Request for Class II Permissive Change(C2PC)

FCC ID: VG8EM134AYYMW

This is a C2PC application for which the previous grant was issued on 05/12/2023.

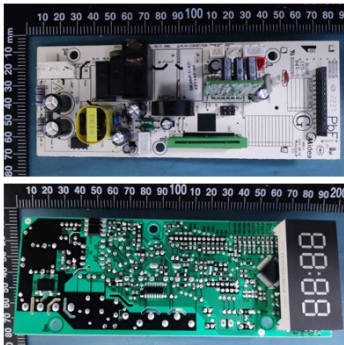
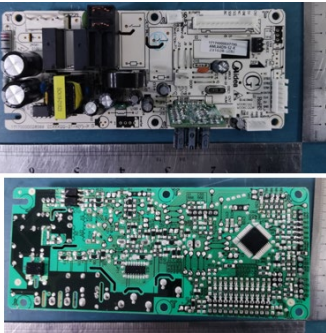
No.:	Original	New	Difference(s)
1			Front view: Controller type is different, the original is Film type keypad, but new is Rotating type knob.
2			Mother board: 1. Modified the peripheral circuit (non-RF circuit) and some individual components and PCB layout. The magnetron and other circuit are exactly same as before. Added a solenoid valve locking mechanism, the original is not.
4	N/A	N/A	Updated interlocking assembly
